**California
Association
Sheet Metal
and
Air Conditioning
Contractors
National
Association**

**Re: 2013 Building Energy Efficiency Standards: Proposed
Revisions to Non-Residential Standards**

This document discusses the following four revisions to Title 24 proposed by the California Energy Commission (CEC), dealing with energy efficiency standards:

Figure 2 Example Comparison of Air- and Water-Side Economizers for the Bay Area (CZ04) for a Commercial Client

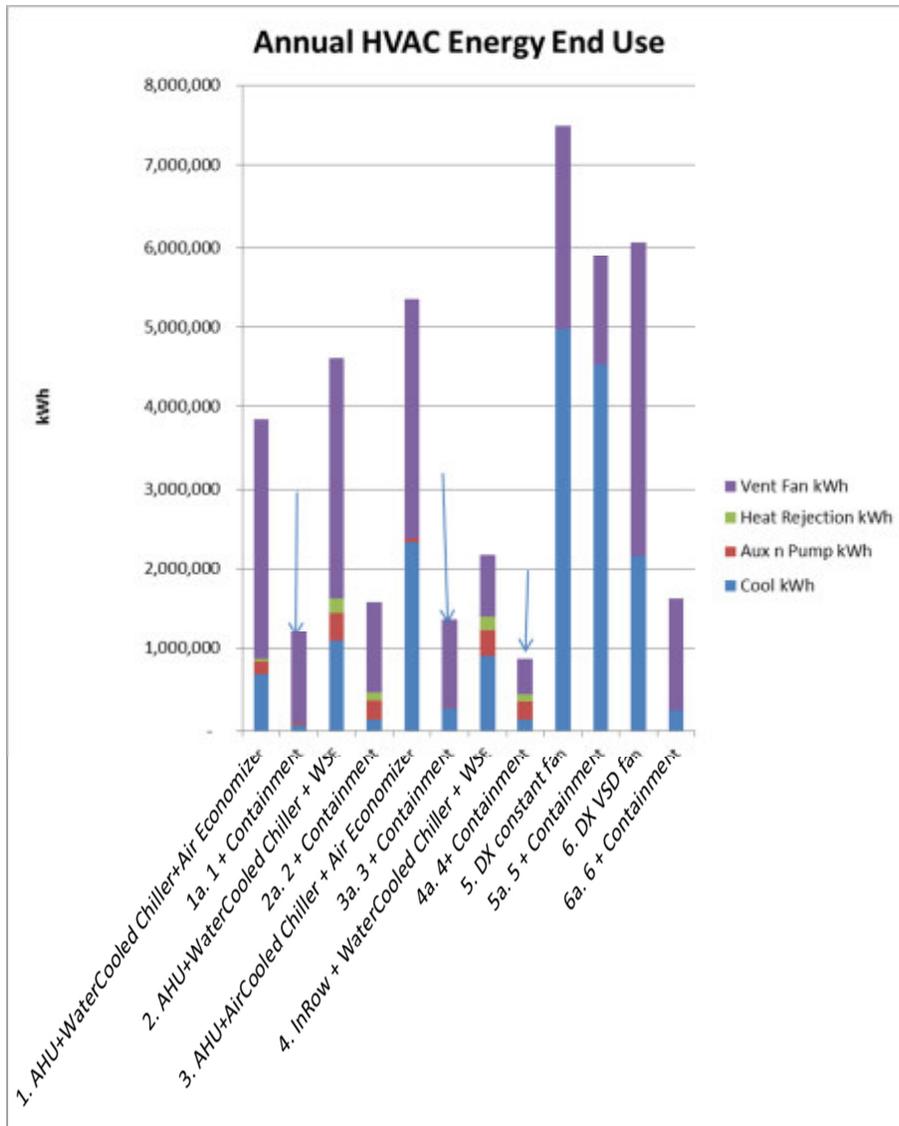
Our firm has done evaluations on air and water economizers on dozens of real data centers for customers including Oracle, Symantec, Kaiser Permanente, Stanford University, eQuinix, Lawrence Berkeley National Laboratories, Sun Microsystems, Vantage and others. We consistently find that both air and water economizers in data centers pay back in less than 5 years for new construction using calibrated models actual construction cost data. Furthermore we have at least a dozen projects with water-side economizers in the two climates that you mention the San Francisco Bay Area (CZ 03 and CZ04) and Southern California (CZ 06). Where we have compared air- and water-side economizers in these climates they are equally effective as shown in Options 1a and 2a in the following figure.

Although this figure indicates that air-side economizers would save more energy at this facility, water-side economizers might be preferred by an owner who is concerned about gaseous contaminants or maintaining humidity levels in their data center. Furthermore it is harder to retrofit air side economizers than water side economizers in an existing building where a new data center is being added. We feel that giving the industry a choice between either air- or water-side economizers strikes a balance between energy savings and flexibility.

We greatly appreciate your explanation of this issue and have no further concerns with the climatic implications of the economizer requirement.
